Memo

Re: Consultation on an Application

Planning Application Ref: PL/26/0801

Proposal: Erection of a new dwelling

Extract from Site Plan – new landscaping within RPA's

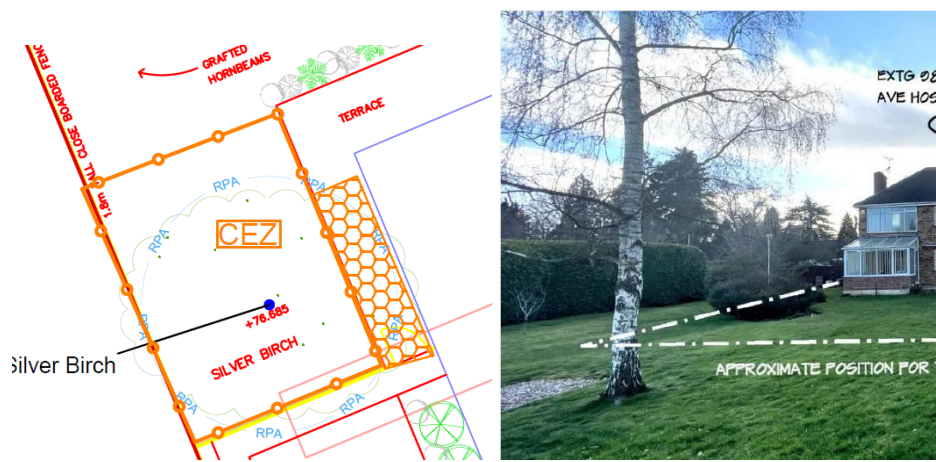
I firstly note that Section 3.2. mentions two Apple trees will be relocated (although only provides one identifying tree number being '#08'). I questioned this in my pre-application advice as removing them and replanting would seem more feasible and relocating trees has a questionable likelihood of establishment – new tree planting is included so it would seem more practical to replace the two Apple trees (see further comments within paragraphs that relate to services and landscaping). These trees have not been included in the tree survey, so I am unclear on their size, maturity and thereby feasibility of relocating them. Methodology for relocating the two Apple trees, has not been provided, nor has any of the other methodology for new landscaping within RPAs, shown in the Site Plan, May 2026, Drawing No. 3902/221, Rev F (Issued 25th March 2026). I have attached extracts below of the Site Plan and TREE PROTECTION PLAN, 17th December 2023,

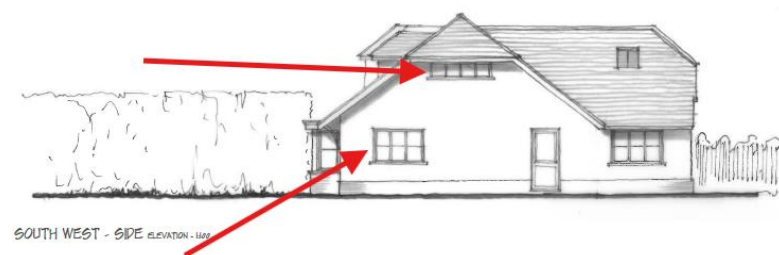
extending over the house footprint and only at 2m clearance, as can be seen in the DAS photos:

As an aside, the DAS photo and indicative boundary fencing position does not seem correct.

Extract from Elevations 2

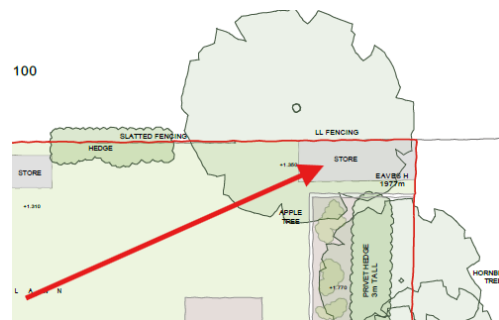
The pressure to prune or fell the Silver Birch will increase due to the juxtaposition of the dwelling and the tree. The canopy is growing in close proximity to windows which is likely to impact light availability and become a maintenance burden for future occupiers. I note the Silver Birch isn't shown in the north-west elevation of the Elevations 2, May 2026, Drawing No. 3902/225, Rev A; however, I attach an extract of the south-west elevation below, highlighting the windows likely impacted by the tree's canopy. No tree constraints plan has been provided to demonstrate shading arcs, which would be prudent so that the shading for future occupiers can be appreciated and assessed, both impacting the dwelling and rear garden amenity space.

Section 3.6. states '*the proposed dwelling is situated outside the RPAs of all retained trees and can be built without impact upon them*'. This is only just the case for the Silver Birch (assuming the RPA is correct) as it is shown extending to the adjacent proposed elevation. It is likely that the footprint of the foundations will extend further than the footprint of the dwelling itself, which I mentioned in my pre-application advice, although the foundation footprint is not clear. Also, as above, the recordings of the tree measurements remain the same as the AIA from 2023, and are likely to have changed during this time, including the size of the RPAs. The foundations, which will use concrete, encroach onto the RPA of the Silver Birch and the use of impermeable liners to prevent concrete leaching into the soil should be used and specified. The finding and treatment of

roots during excavation has not been provided but would be prudent to include given the encroachment onto the RPA.

Extract from Existing Site Plan – unclear works to proposed bike store

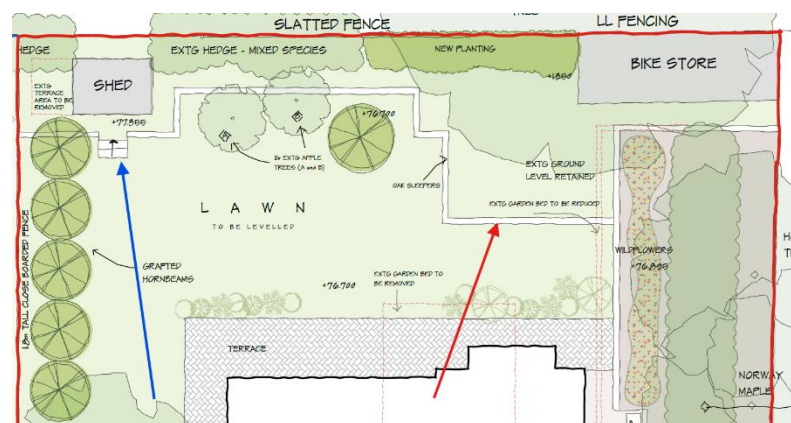
Section 3.7. states *'the path within the RPA of retained birch #02 will be laid above ground using a 'no-dig' surface. As will the bin store base and the section of the adjacent driveway close to the trees in group #10'*. Whilst this is acceptable in principle, the bike store is located within the RPA of the Sweet Chestnut in adjacent land, and any works required to it are not clear – the Existing Site Plan, July 2023, Drawing No. 3902/101, Rev D, labels this as just a 'store', so it is unclear whether this will be demolished & rebuilt, remain the same, or have any alterations.

Extract from TPP – existing parking space to be removed and '*granite rumble strip to contain gravel from driveway*'

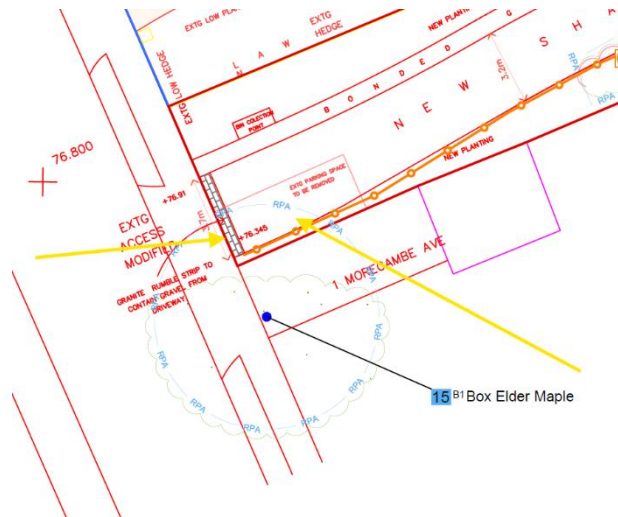
Section 3.8. states *'the drive does pass within the circular RPA of the off-site box elder #15. However, the area of the drive is already providing parking and root presence is considered likely to be minimal. Thus the new access is deemed low-impact and unlikely to result in detriment to it.'* The RPA has not been adjusted to suggest roots will not be present and thus extends into the area where the existing parking space is to be removed. It is possible that once the existing hard surfacing has been removed, roots may

be found beneath and thus the finding and treatment of roots should be specified as the RPA is within this area. The works to the '*granite rumble strip to contain gravel from driveway*' access point are unclear. The access is being widened and whether this will require excavation is not detailed, even though a section of it is within the RPA, so further clarity is required – assuming finding minimal roots yet not adjusting the RPA and providing associated working methodology to minimise the impact to tree health makes this questionable.

Extract from Proposed Site Plan – fencing beneath canopy of Silver Birch

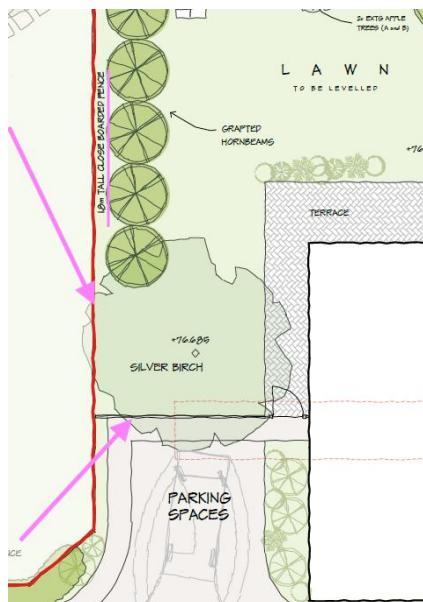
Whilst Section 4.45. 'Stages for installing wooden posts', details the methodology for installing the fencing, which is acceptable in principle, the existing/retained vs proposed fencing is not clear on any of the plans. Some of the fencing is located beneath the canopy of the Silver Birch, which only has 2m of ground clearance - some of the fencing proposed is 1.8m in height so clearance pruning is likely required. The boundary treatment between the parking spaces and the garden is unclear but is shown as a fence in the elevations.
